REQUEST FOR TECHNICAL REVISION (TR) COVER SHEET

File No.: M- 1977-211 Site Name: Pikeview Quarry

Updates to the reclamation drainage design based on conditions in the field and granitic

Reference: Technical Revision (TR-23), Pikeview Quarry, M-1977-211

PROJECT
PIKEVIEW QUARRY RECLAMATION PROJECT
OVERALL DRAINAGE PLAN

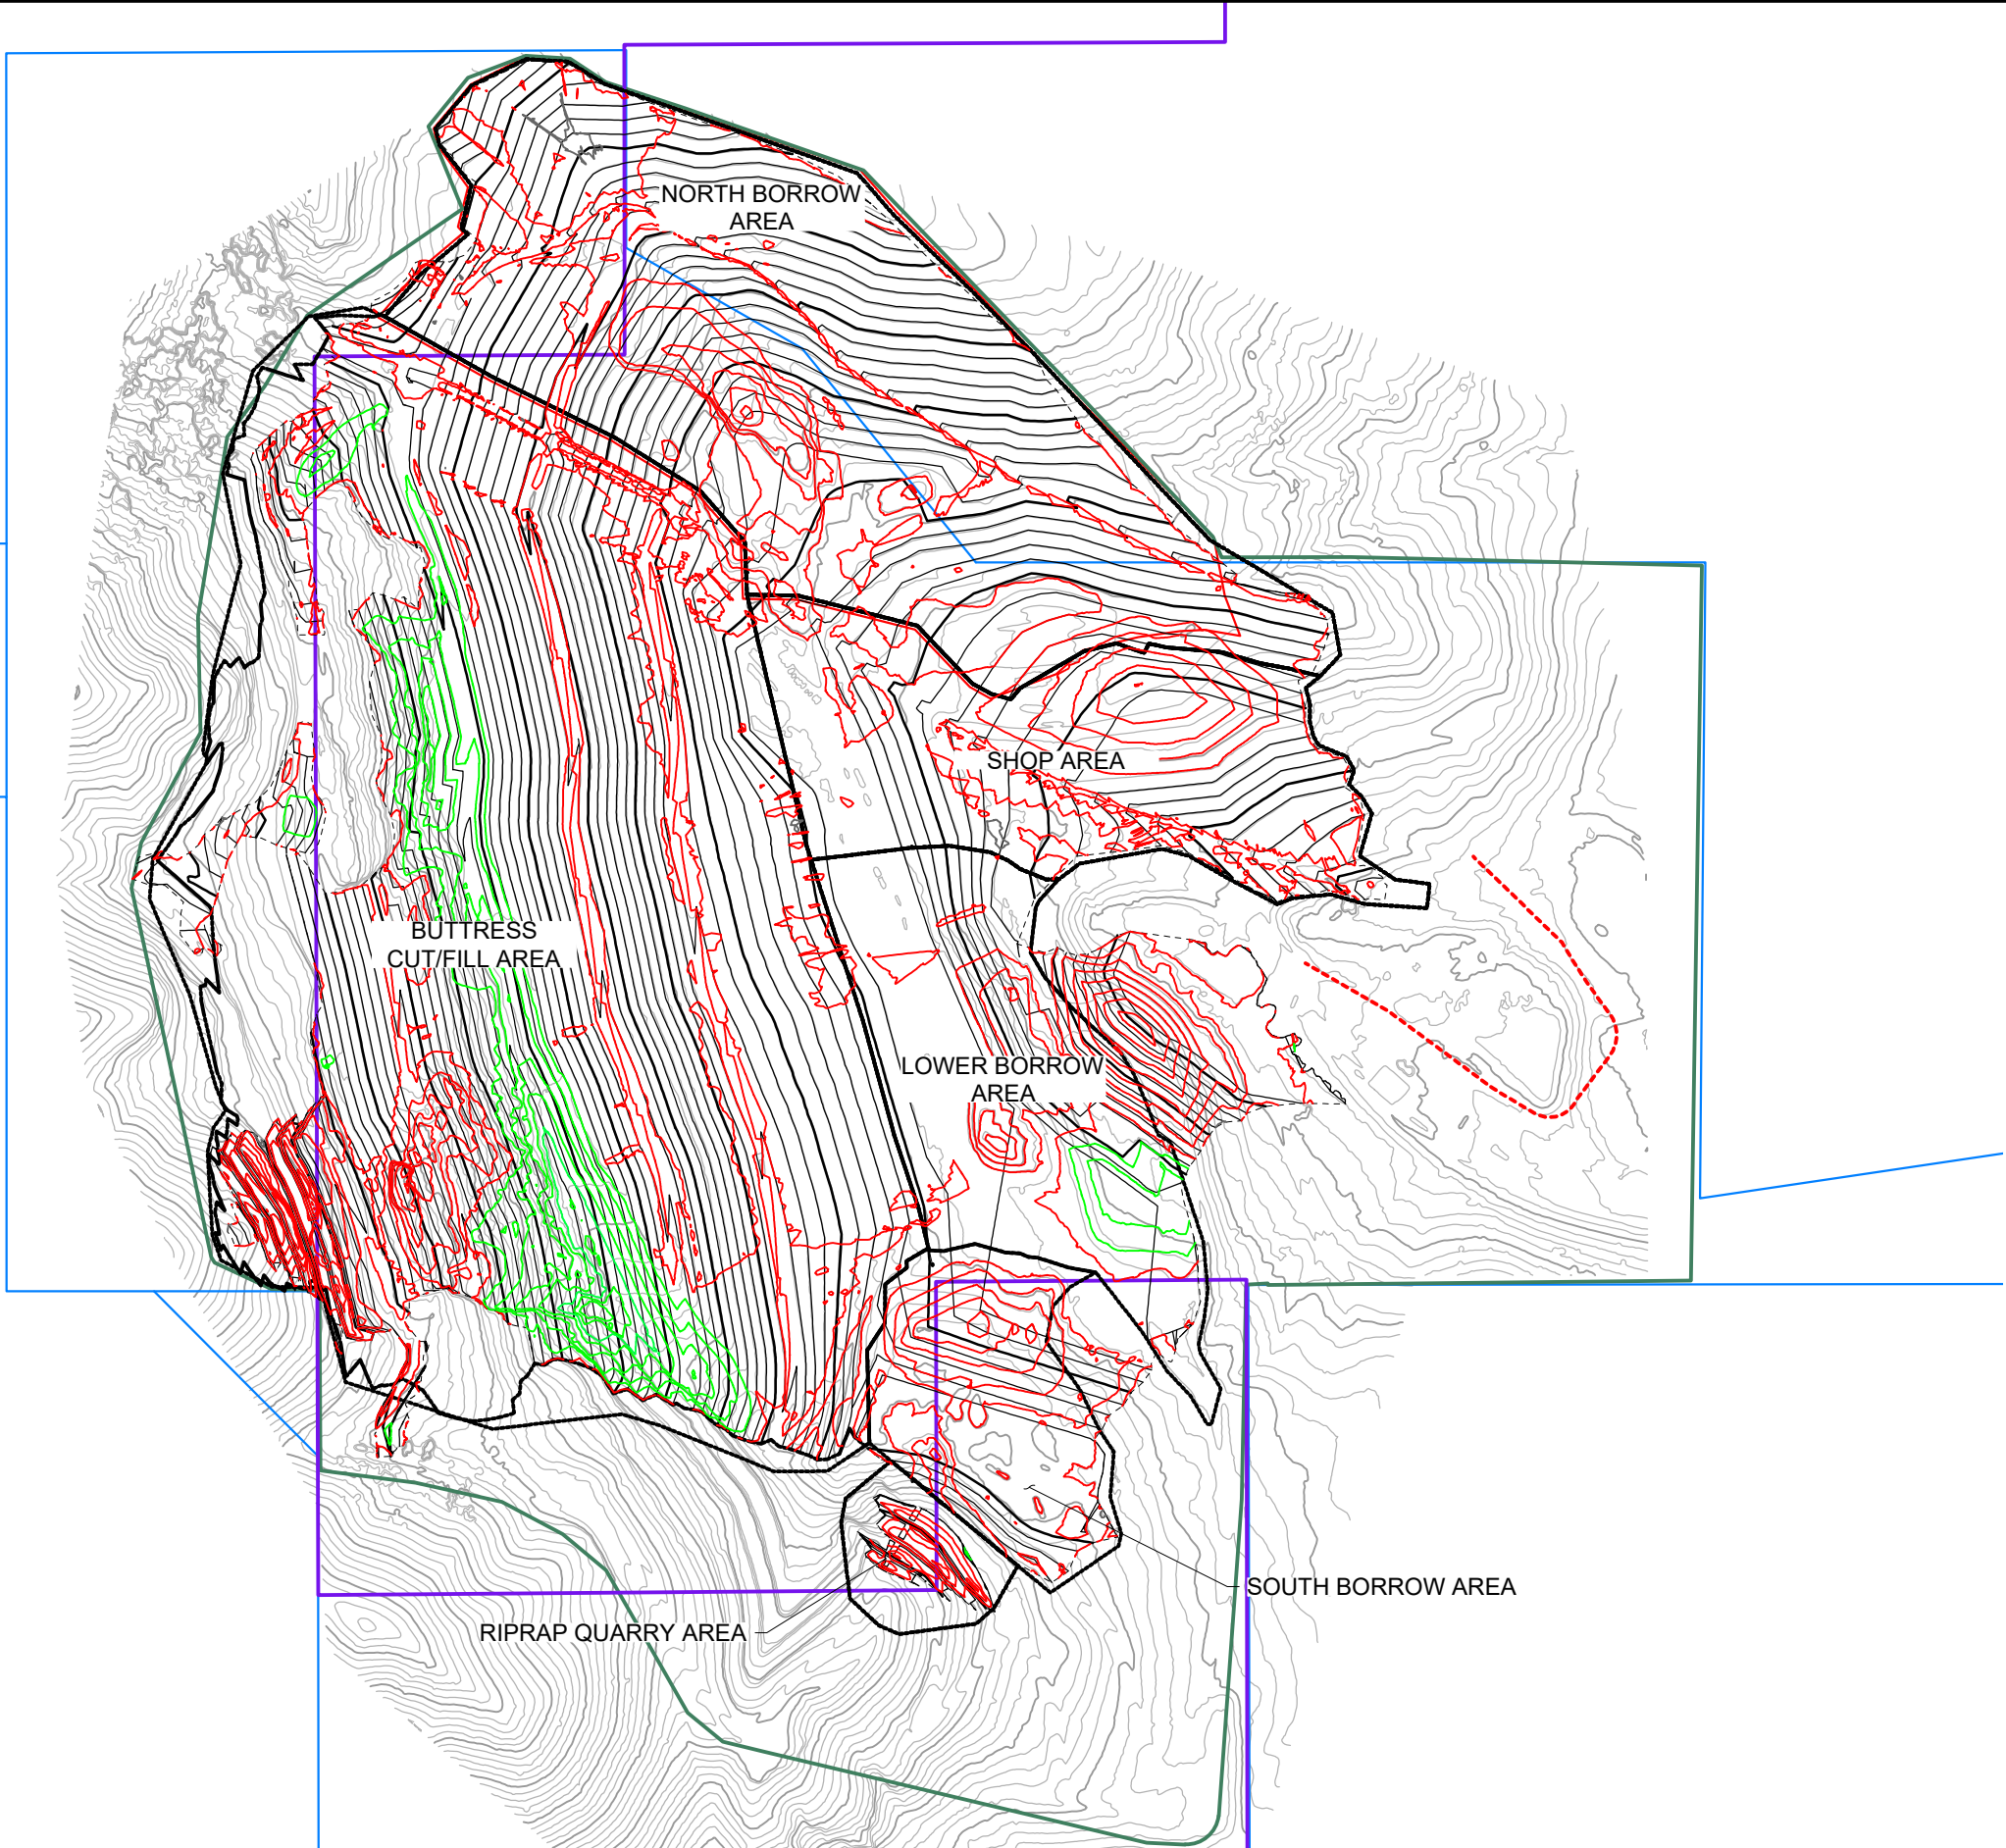
Updates to the reclamation drainage design have been made due to the conditions in the field and the granitic bedrock that will be left in place. This TR contains updated information and is intended to be reviewed with Exhibit G of the Amendment 4 for model input parameters and background information. Below summarizes the additional channels and justification. The channel designs are summarized in Table 1.

The revised hydrologic model reports and design drawings have been included as attachments.

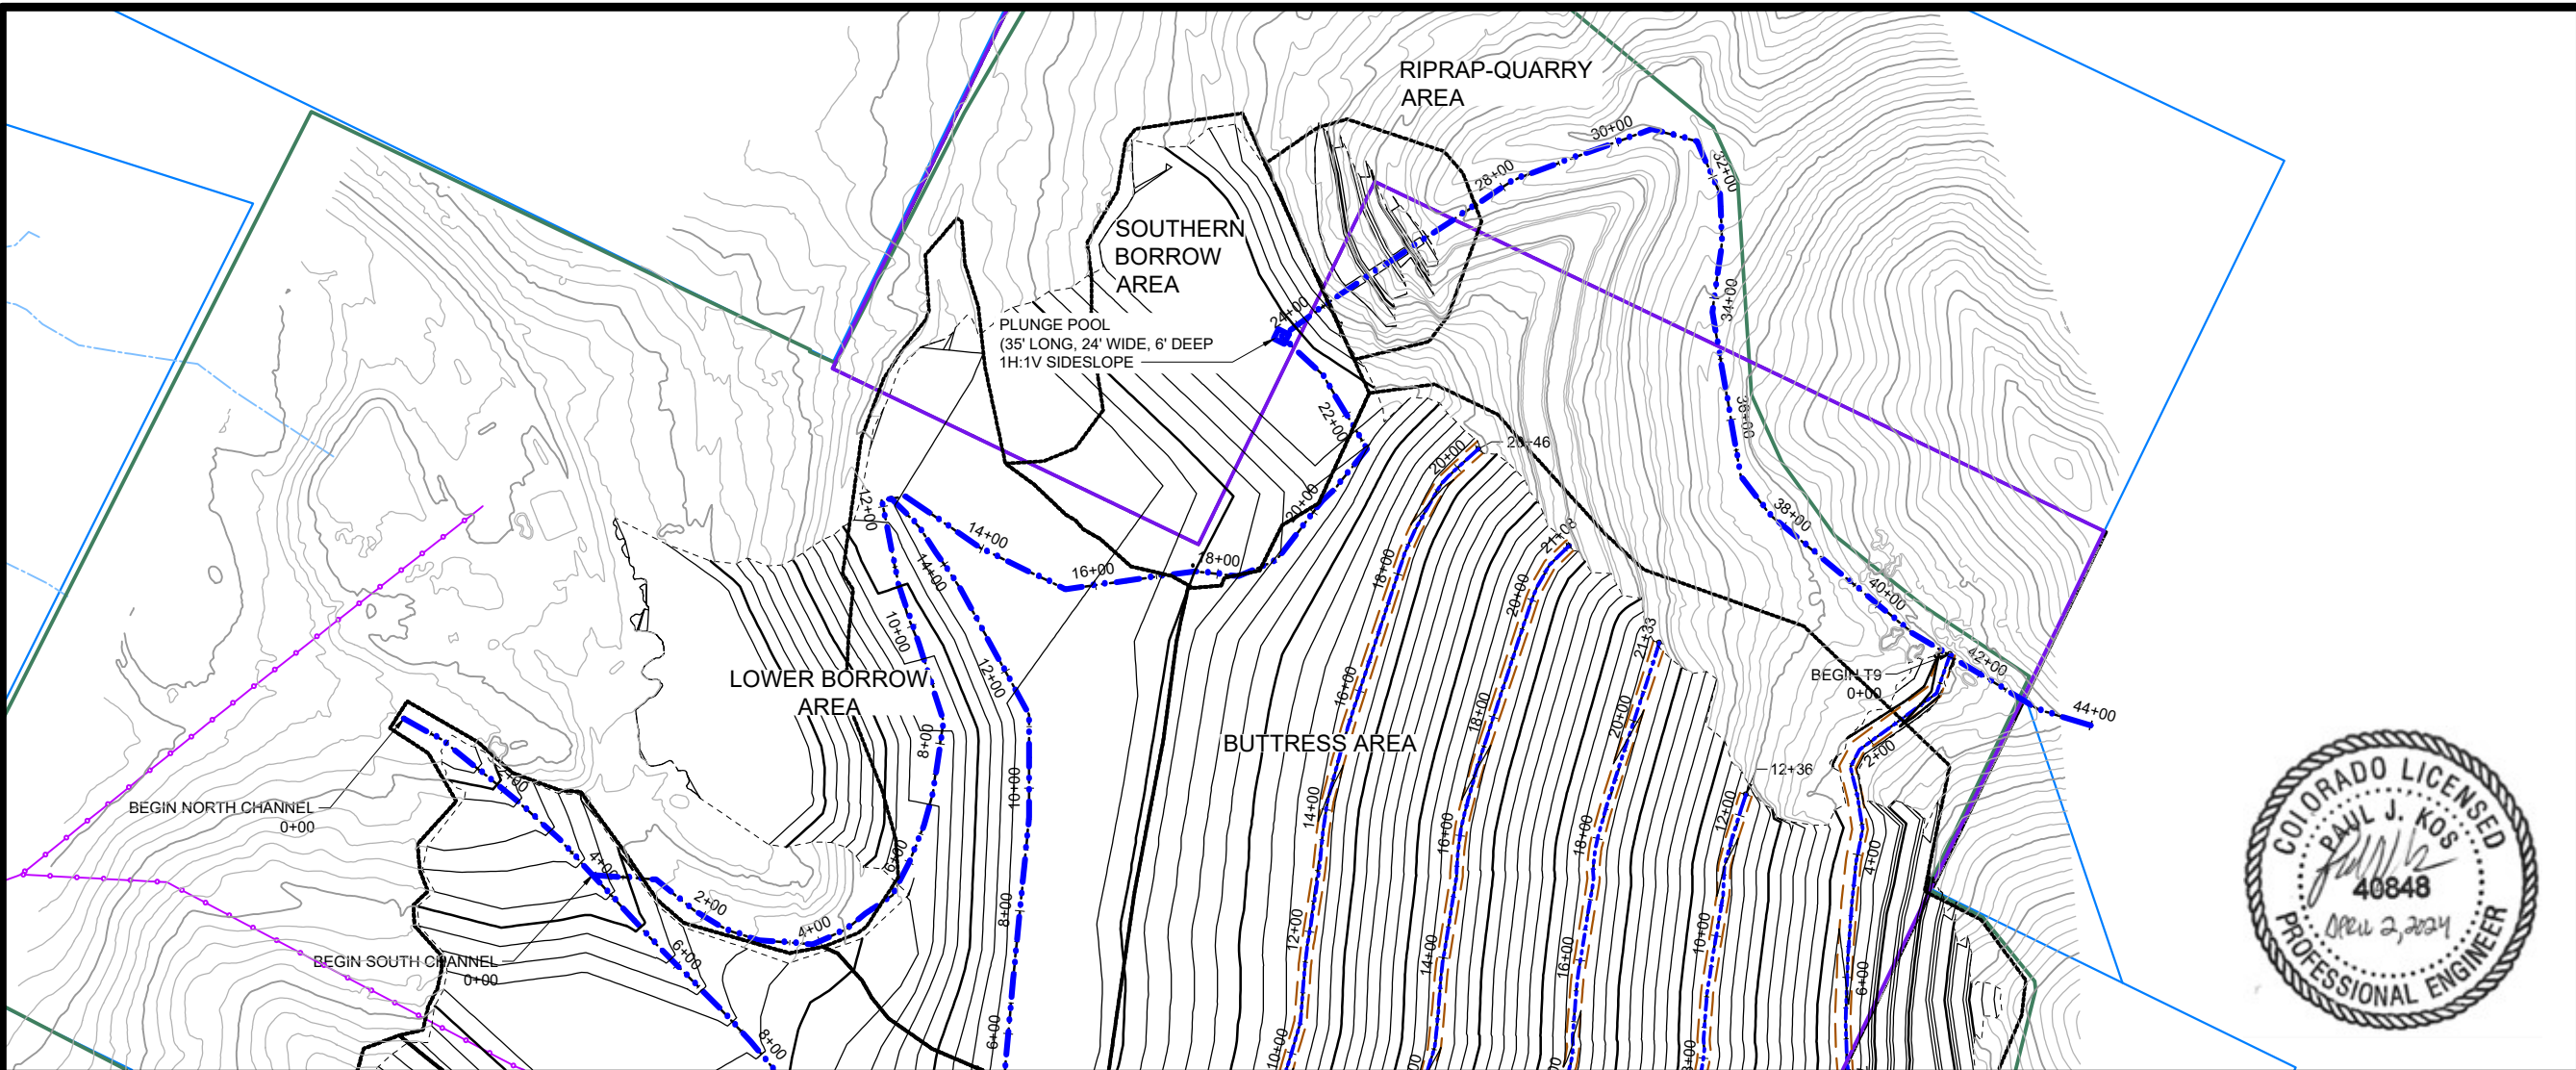
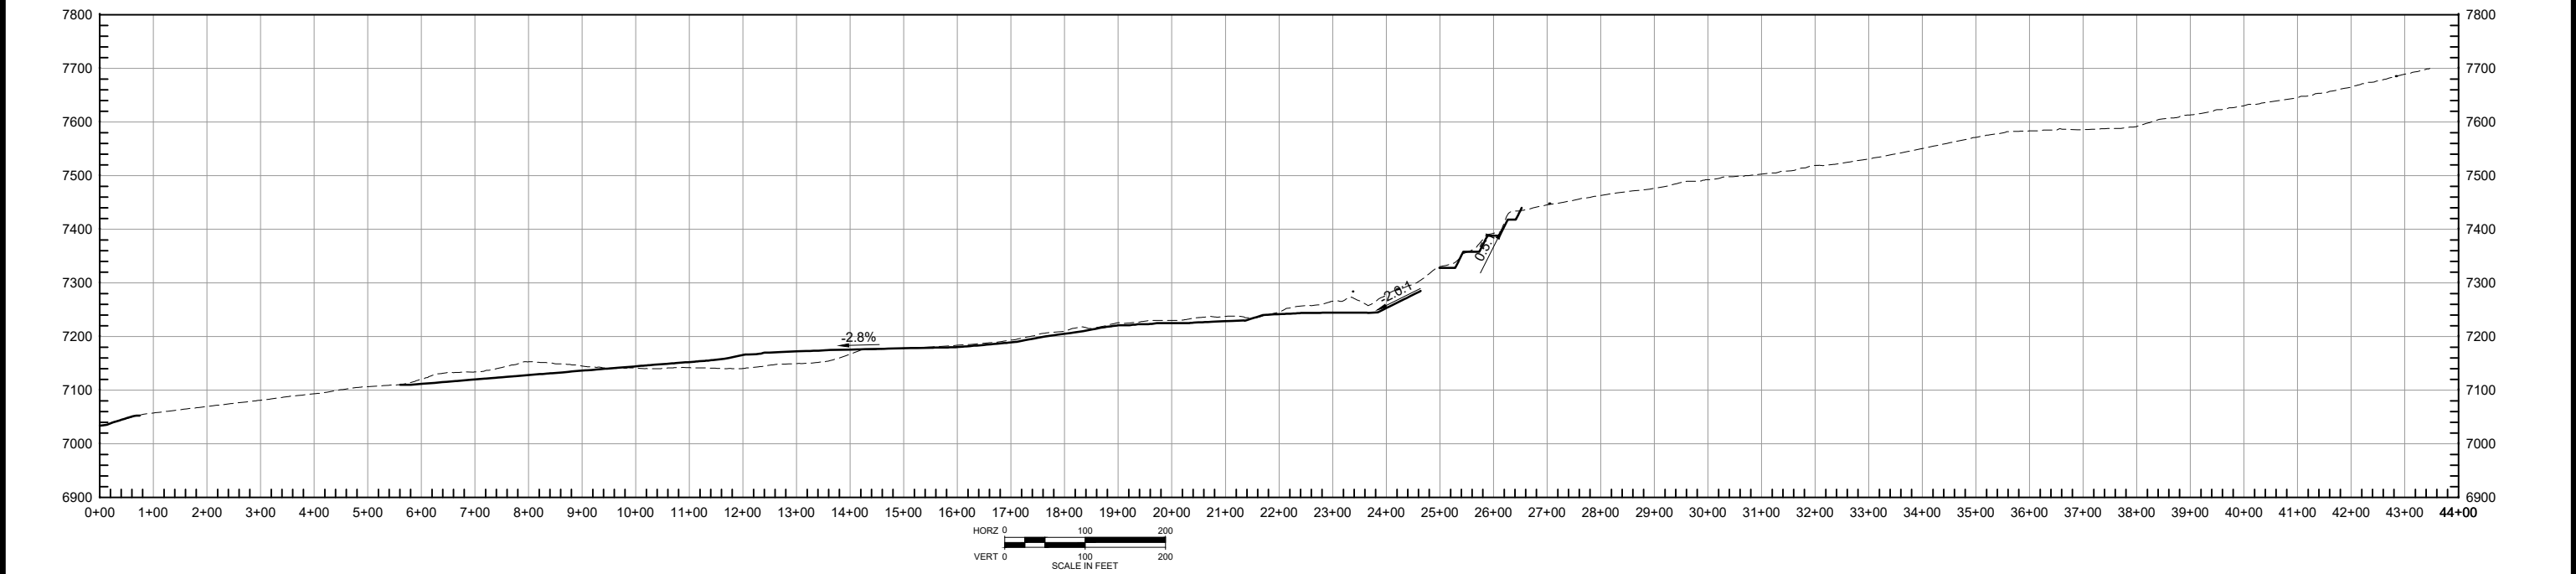
- Cross Channel – This channel routes the flows from the upper area to the main channel. Reclamation construction revealed the presence of competent bedrock that the water needed to be diverted around from the previously approved design. The Cross Channel design has been separated into three sections based on the channel gradient and the calculated design flows.

- Channel T9 – Diverts water collected from the south peak watershed towards the south channel.
- Channel T8 – Due to the rock outcroppings that will remain in place, proposed terrace channel T8 was rerouted to avoid the outcroppings and to connect with terrace channel T7. Terrace channel T8 will have two segments. The upper segment design follows the terrace channel design. The lower/steep segment includes a riprap armored channel that slopes down to terrace channel T7.

- Channel T7 – The alignment of this channel did not change, but the design flows increased due to the additional flows from terrace channel T8. This channel has been divided into an upper and lower section. The upper segment is upstream from the confluence with T8, and the design follows the terrace channel design. The lower segment considers the flows from T8.
